SPECIAL PROVISIONS  
 ARIZONA PROJECT RAM-600-1-507  
 STATE ROUTE 117  
 NORTHEAST OUTER LOOP HIGHWAY (SR117)(PHOENIX URBAN AREA)  
 PRICE ROAD DRAINAGE TUNNEL  
 DRAINAGE TUNNEL, PUMP STATION, ACCESS SHAFT AND DROP STRUCTURES

Addendum (1)  
RAM 600-1-507  
Sheet 1 of 10  
November 20, 1987

Addendum (2)  
RAM 600-1-507  
Sheet 1 of 1  
December 3, 1987

2. Dwg. No. C-11

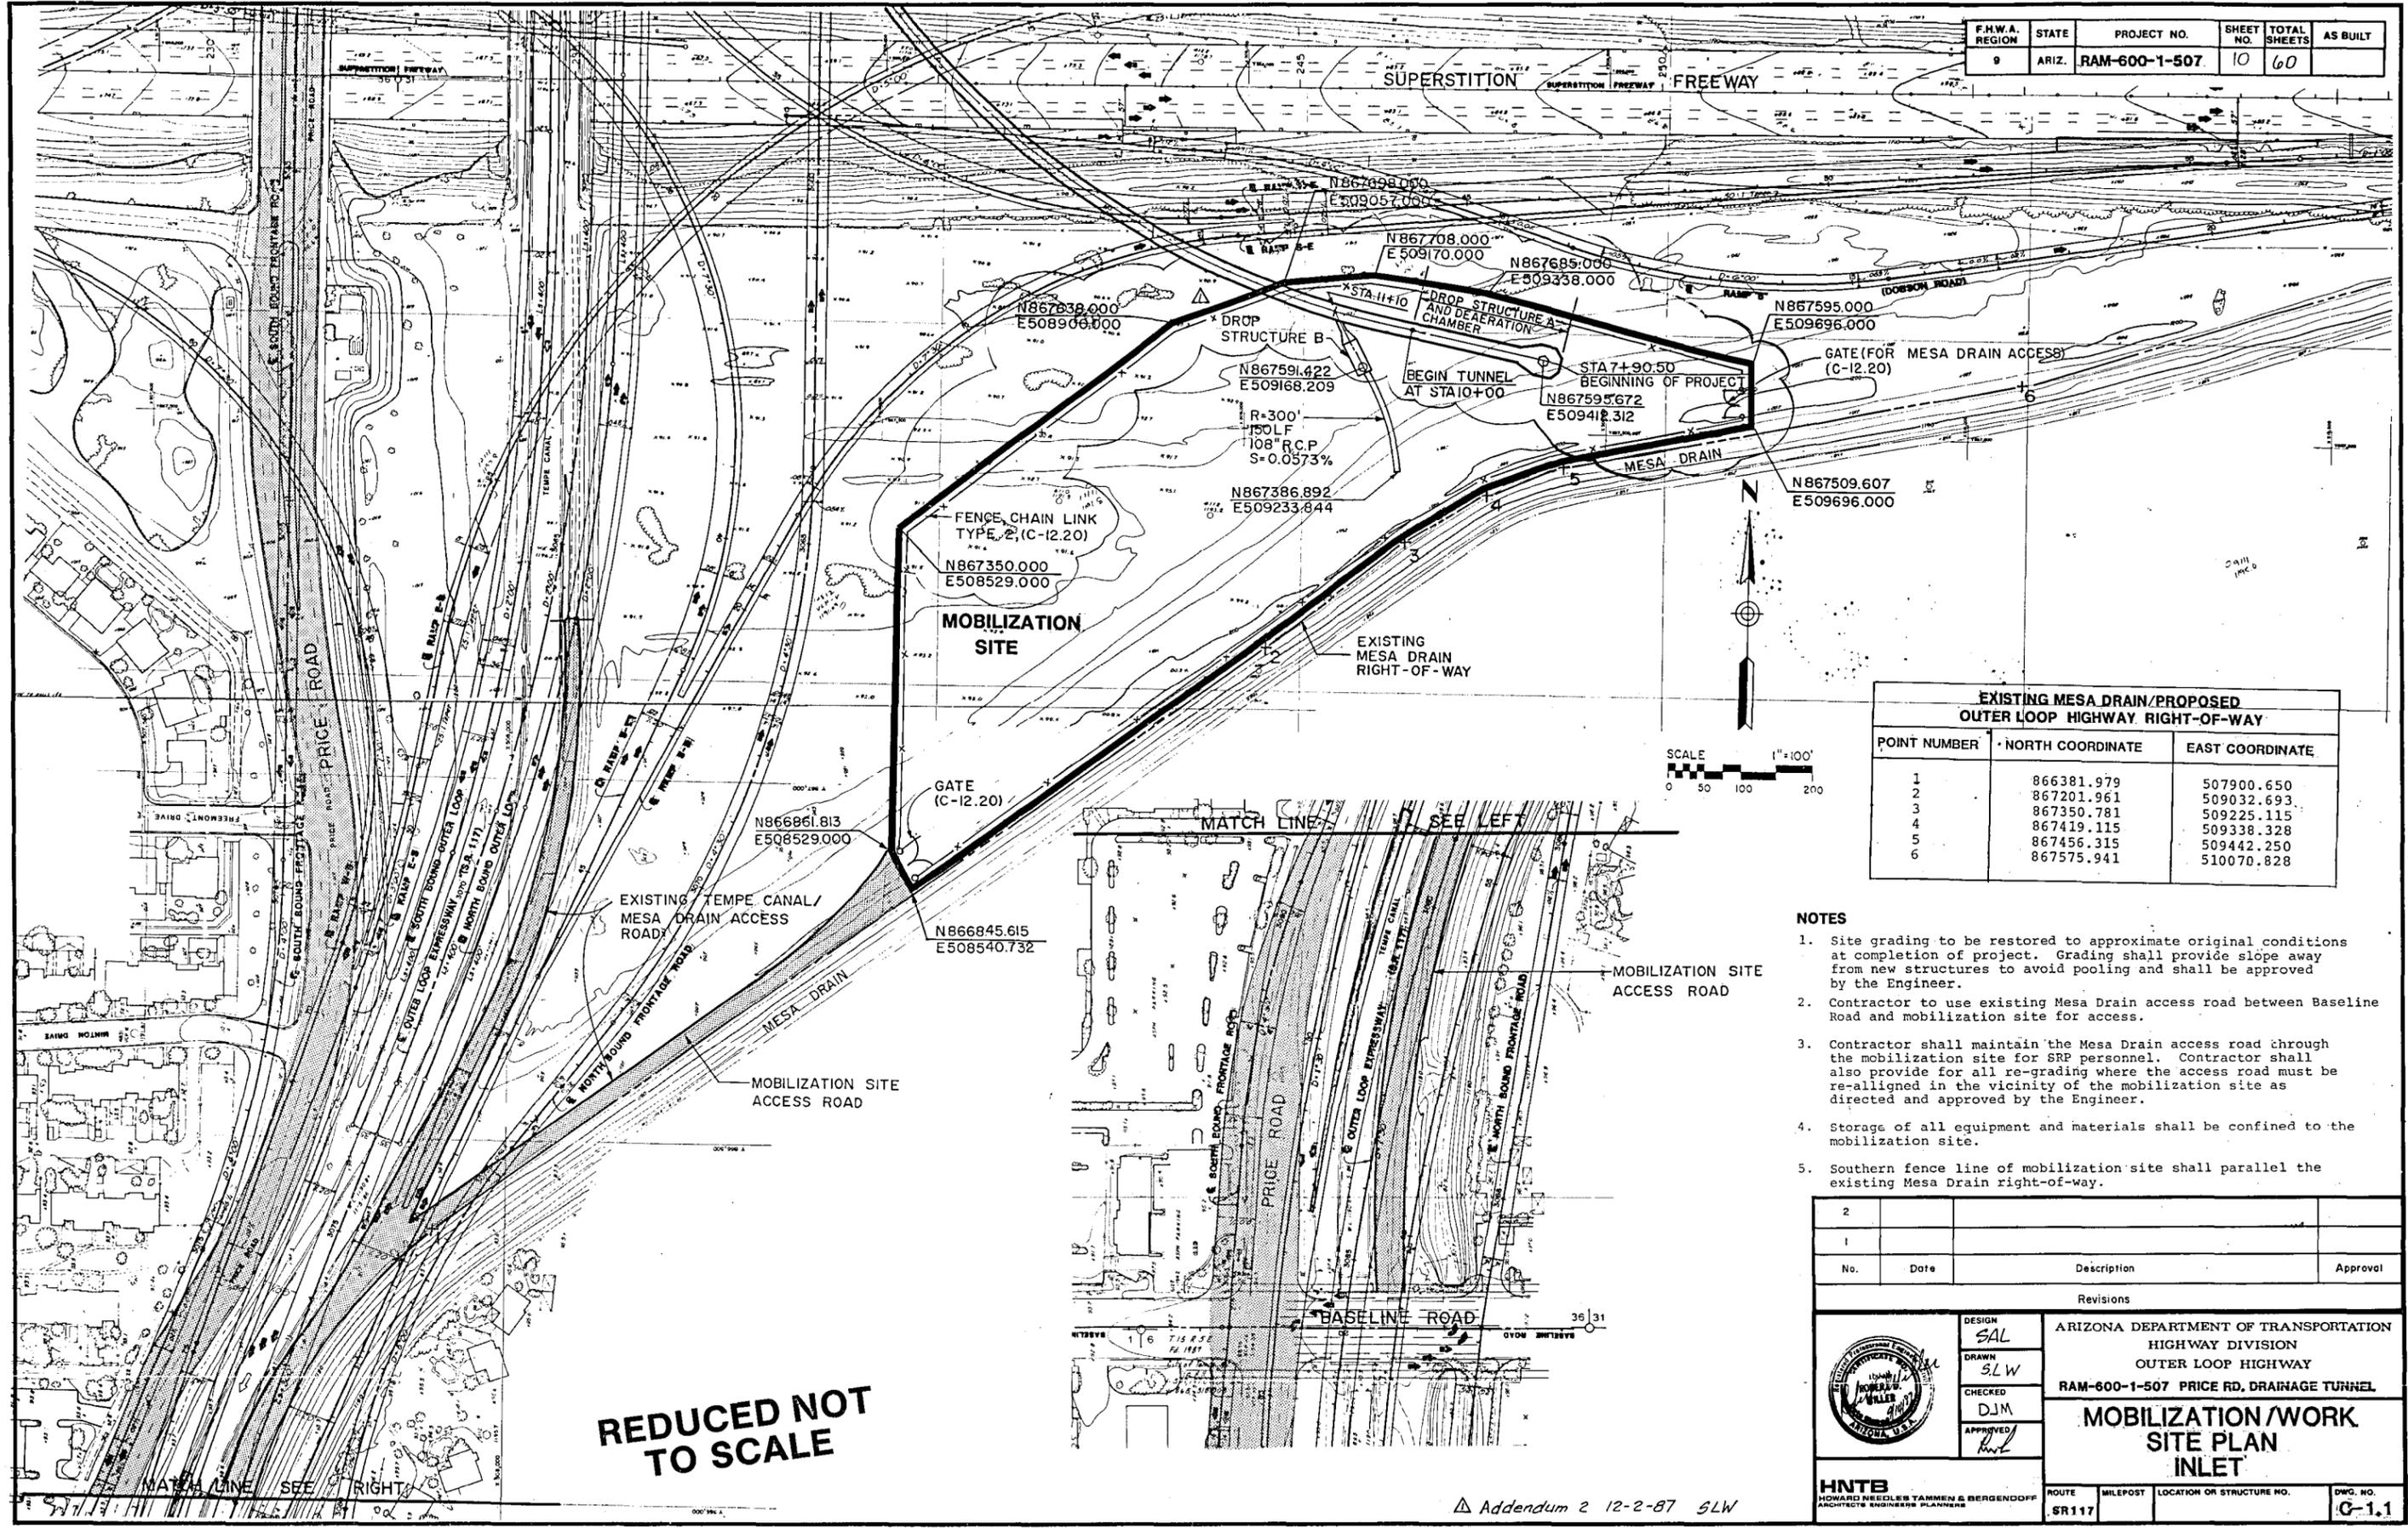
This drawing has been revised. Please exchange the original sheet  
with its replacement included in this addendum.
